Microcomputer Technical Information

μ PD789014 Subseries Usage Restrictions	Document No.	SBG-DT-03-0185-E	1/2
	Date issued	July 18, 2003	
	Issued by	Microcomputer Group 2nd Solutions Division Solutions Operations Unit NEC Electronics Corporation	
Related documents μ PD789014 Subseries User's manual: U11187EJ3V0UM00 μ PD789011, 789012 Data sheet: U11095EJ1V1DS00 μ PD78P9014 Data sheet: U10912EJ1V0DS00	Notification classification	√	Usage restriction
			Upgrade
		√	Document modification
			Other notification

μPD789014 Subseries Usage Restrictions

Basic Timer Configuration

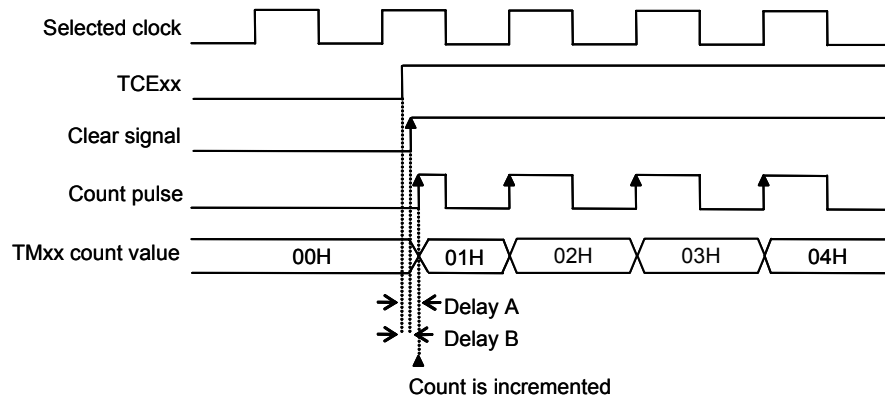
When the 8-bit timer/event counter is used, an error of up to 1.5 clocks is generated after the timer has been started until a match signal is generated. This is because a rising edge is detected when the timer is started while the selected clock is high, which results in the count value getting incremented.

- The selected clock and the count operation flag (TCExx) are ANDed, and the result is supplied to the counter
- The TMxx counter value is cleared when the count operation flag (TCExx) is set

If a count pulse is delayed for the clear signal (“delay A > delay B”) as the result of setting the count operation flag (TCExx) while the selected clock is high, the TMxx count value is incremented. An error of up to 1.5 clocks is generated.

Case when an error of up to 1.5 clocks is generated

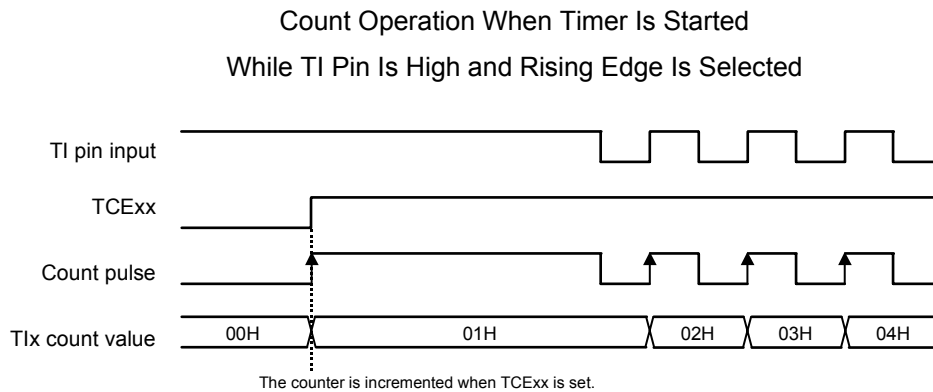
Remark See Basic Timer Configuration above for details of the selected clock, TCE, clear signal, and count pulse.
